Letter of Response

Project Title: Lion Petroleum Convenience Store

Response to Fire Plan Review

Response to Plan Review

SANITARY ISOMETRIC 2

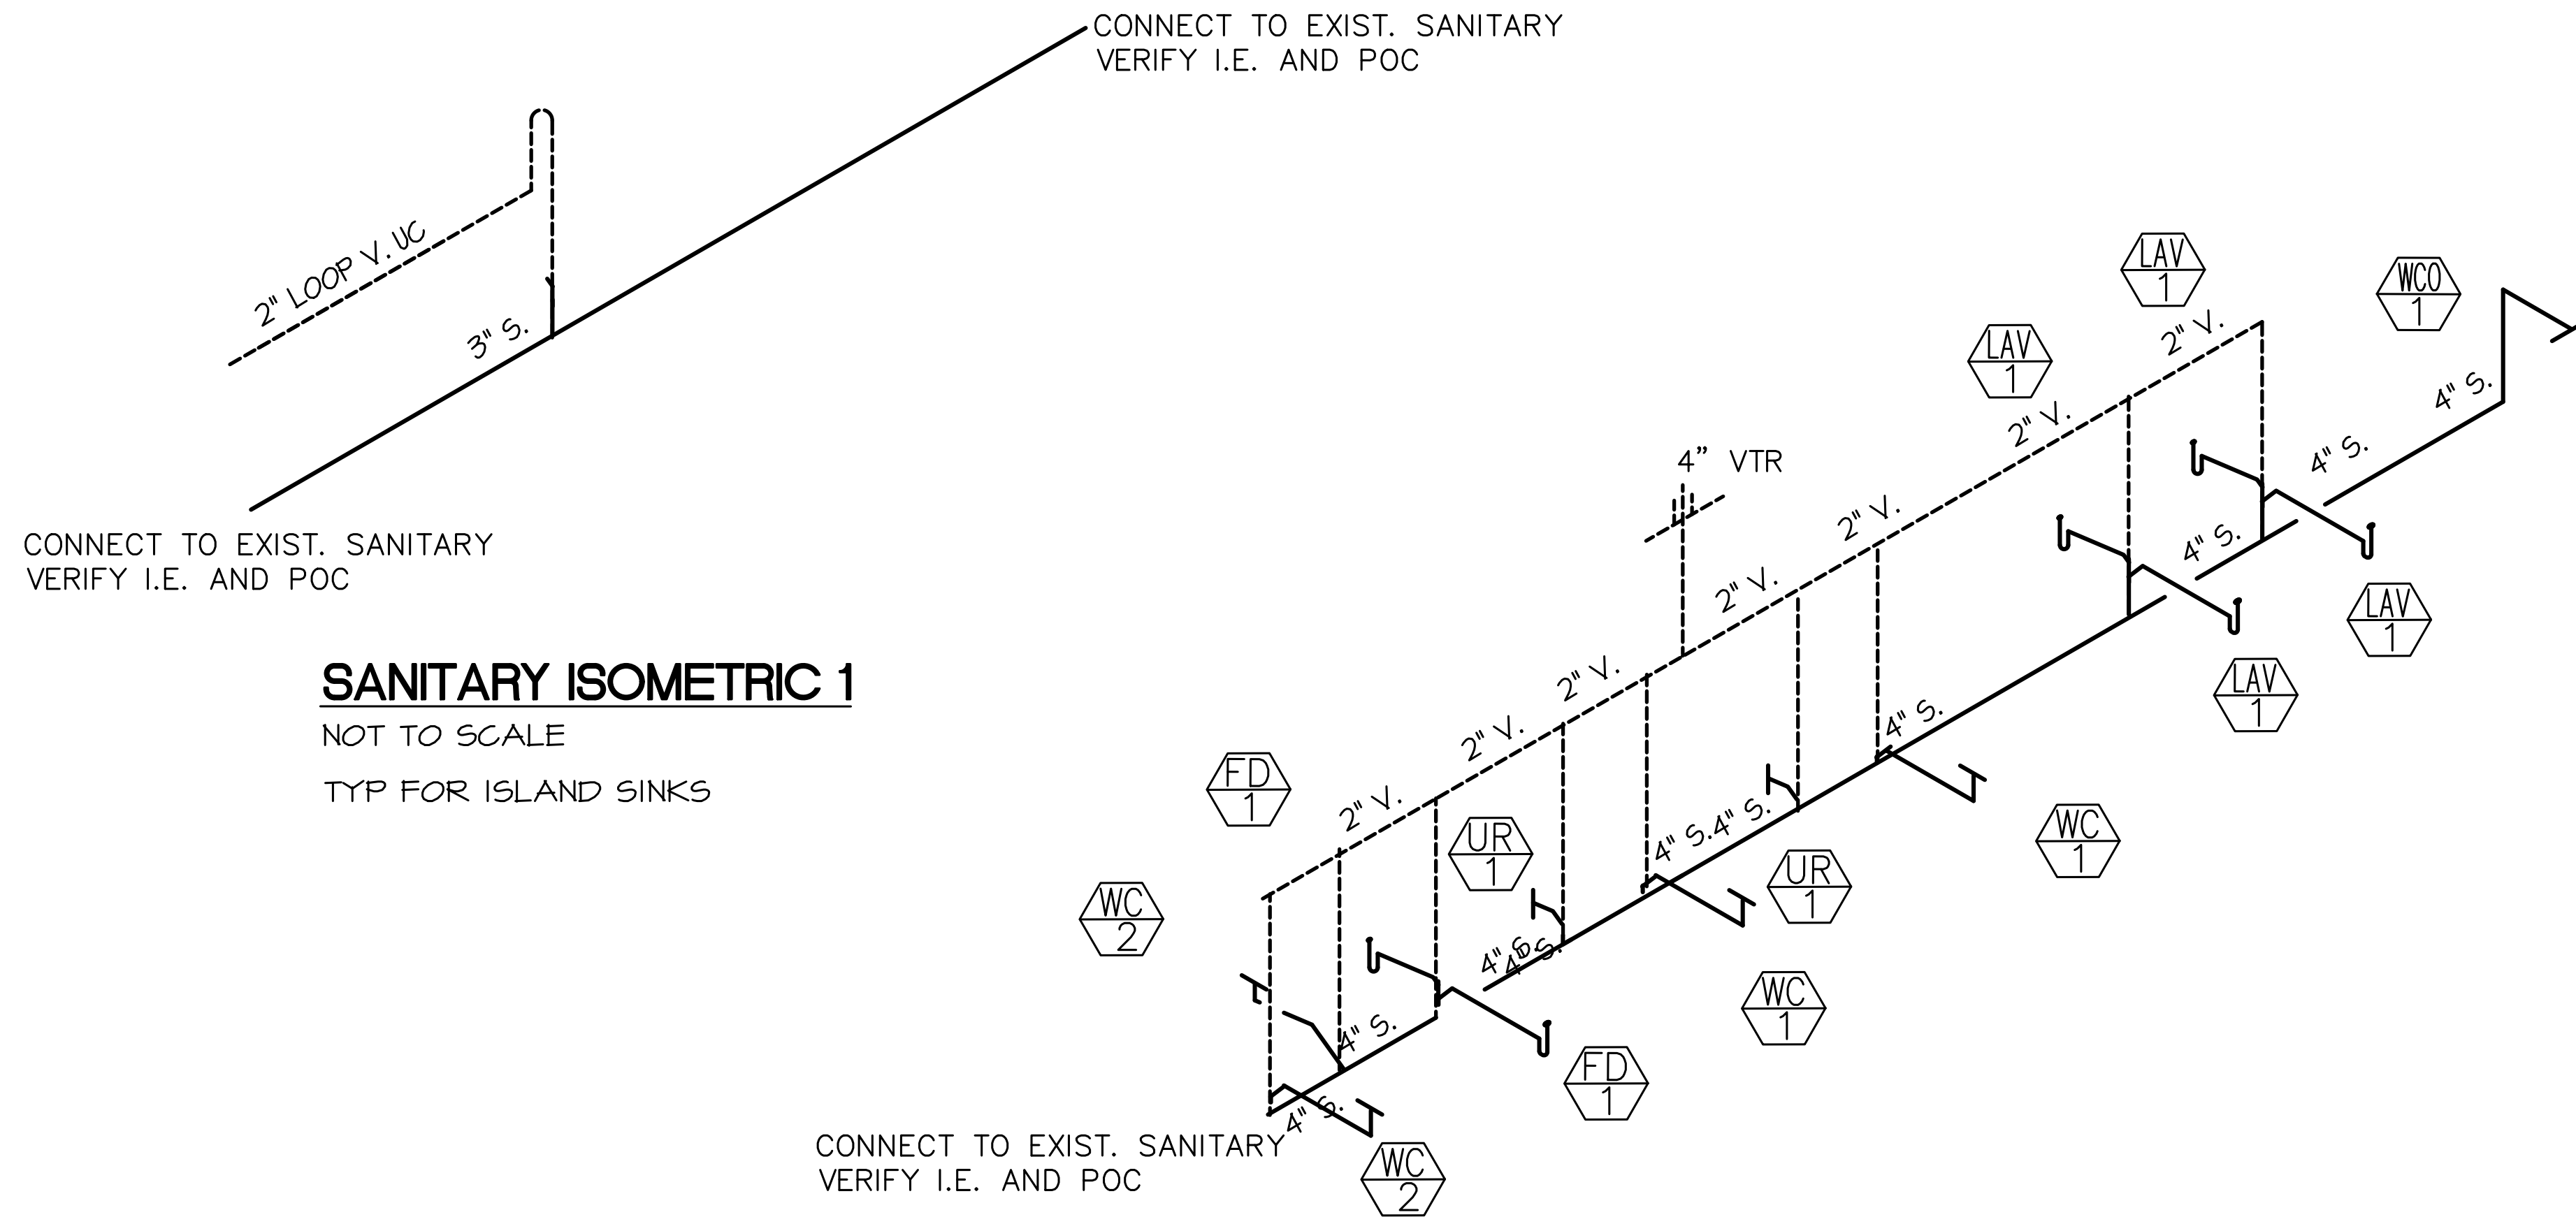
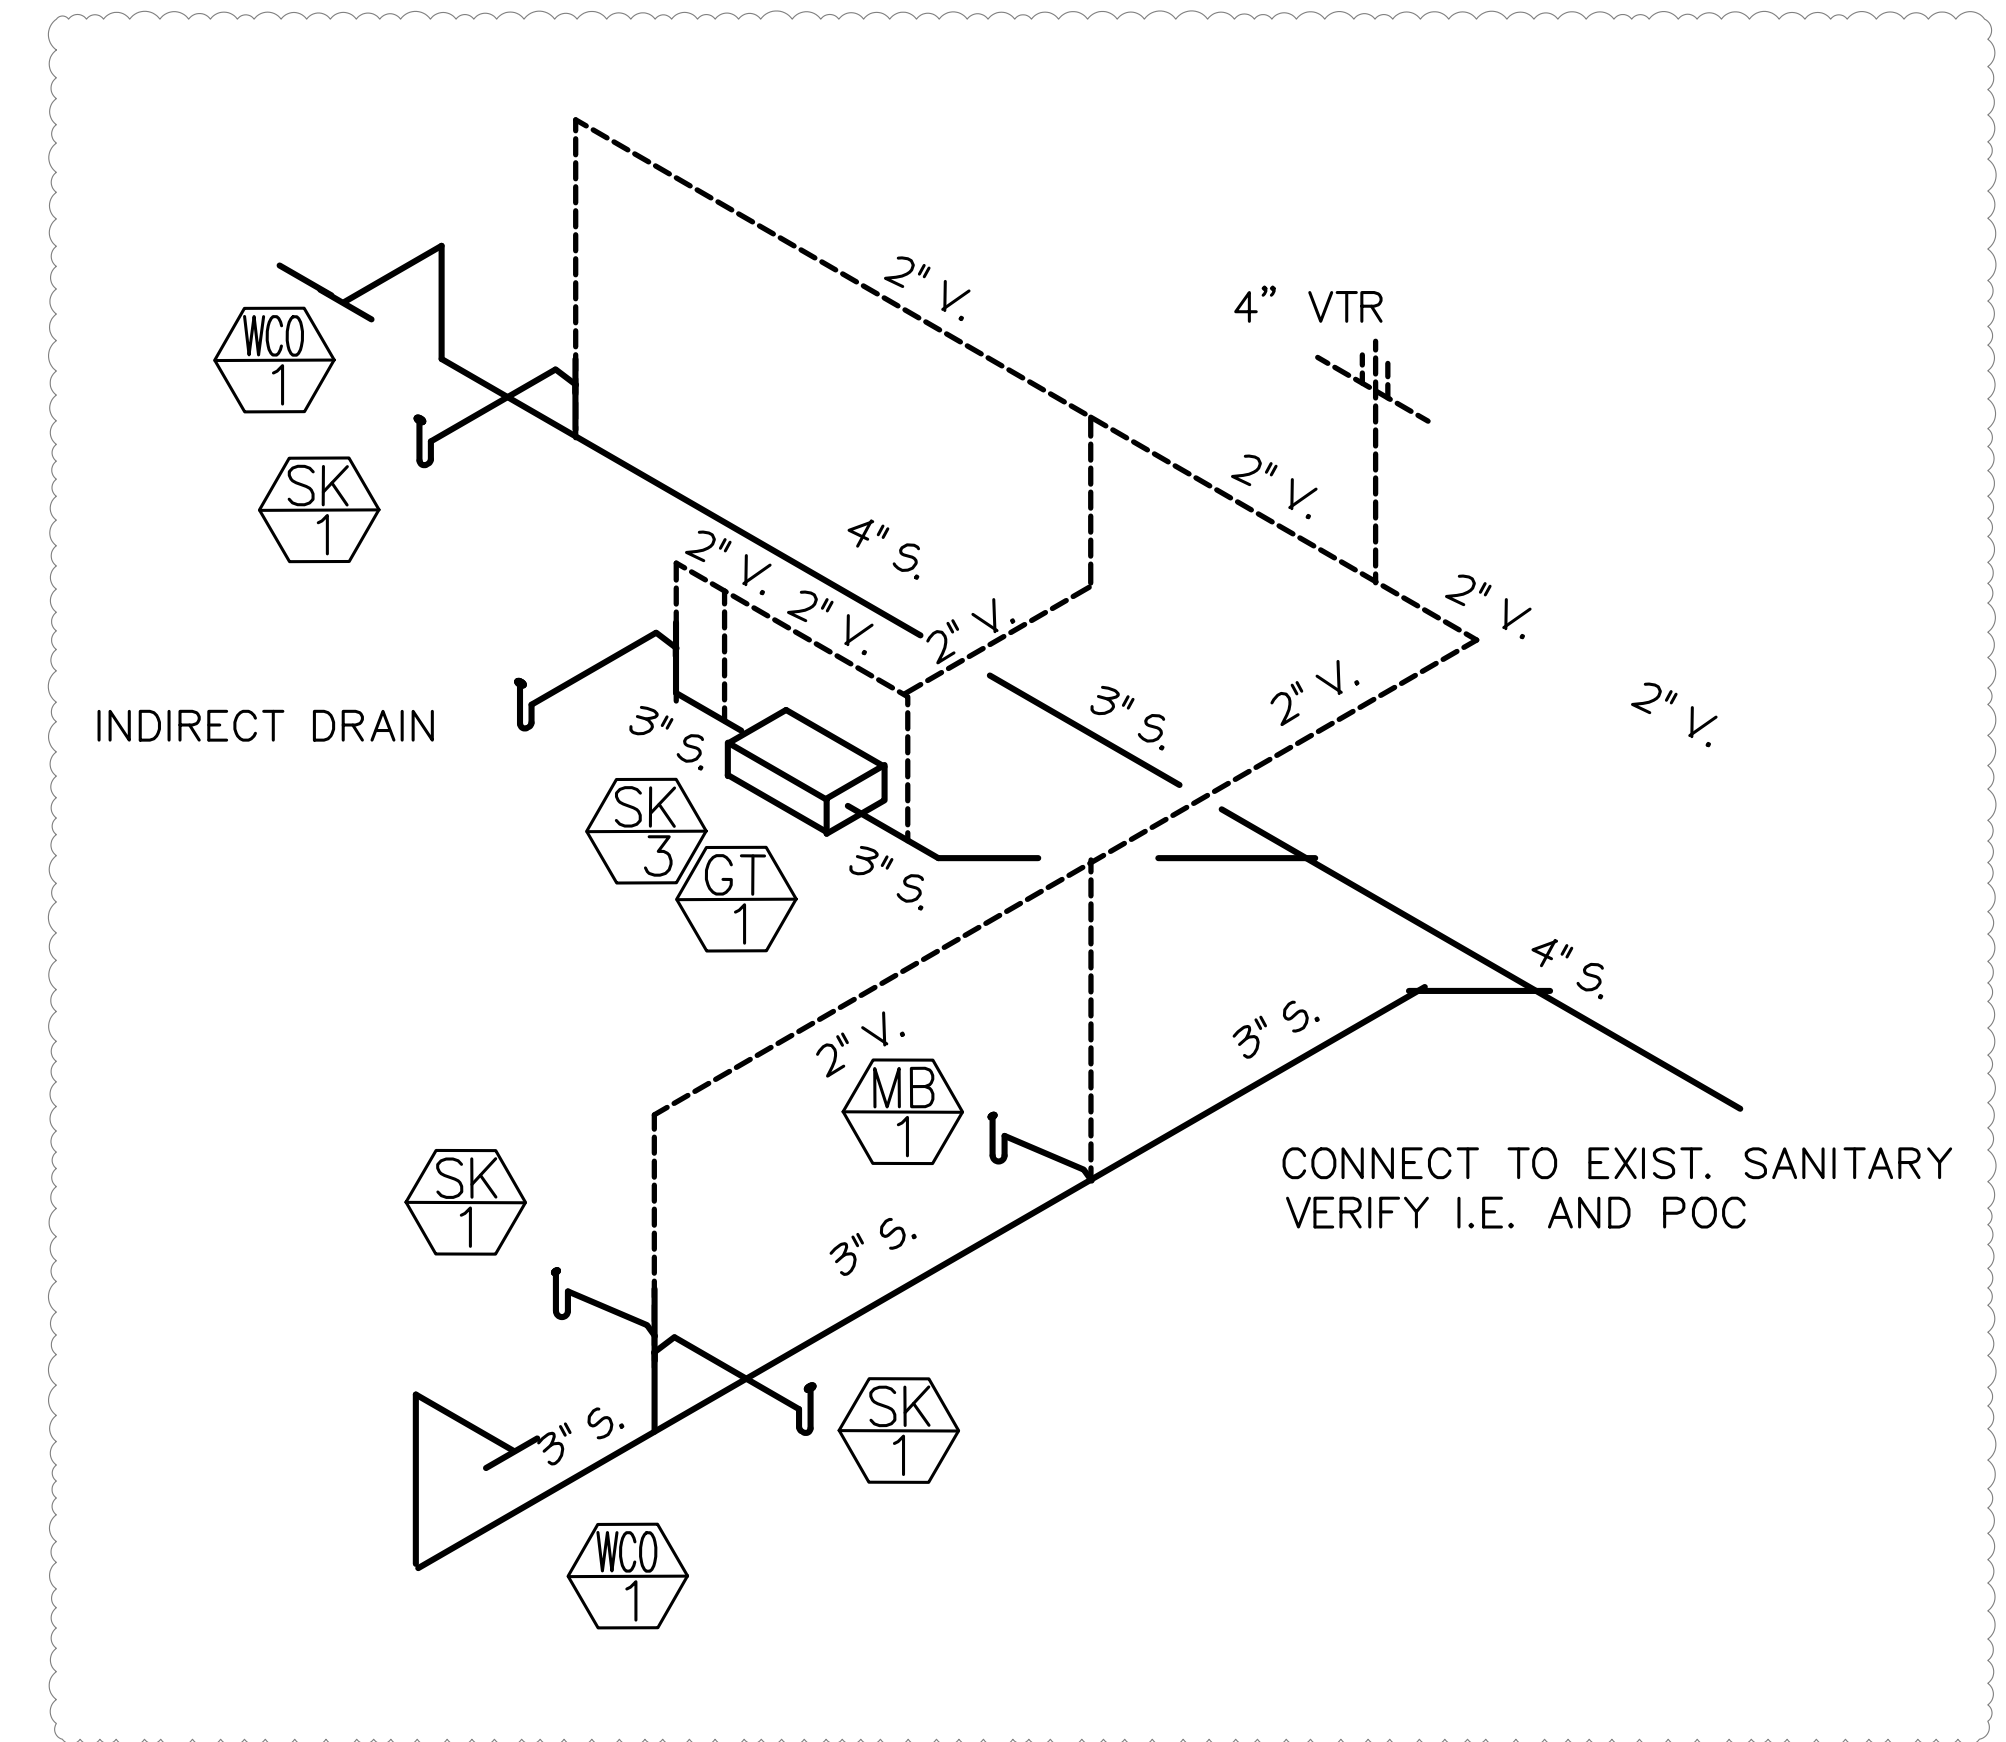
ITEM 14 FROM JOE FROSSE: WATER HAMMER ARRESTORS SHOWN ON WATER ISOMETRICS SHEET P3

ITEM 16 FROM JOE FROSSE: ADDED NOTE ABOUT INDIRECT CONNECTION ON ISOMETRIC ON SINK SK-3 SHEET P3
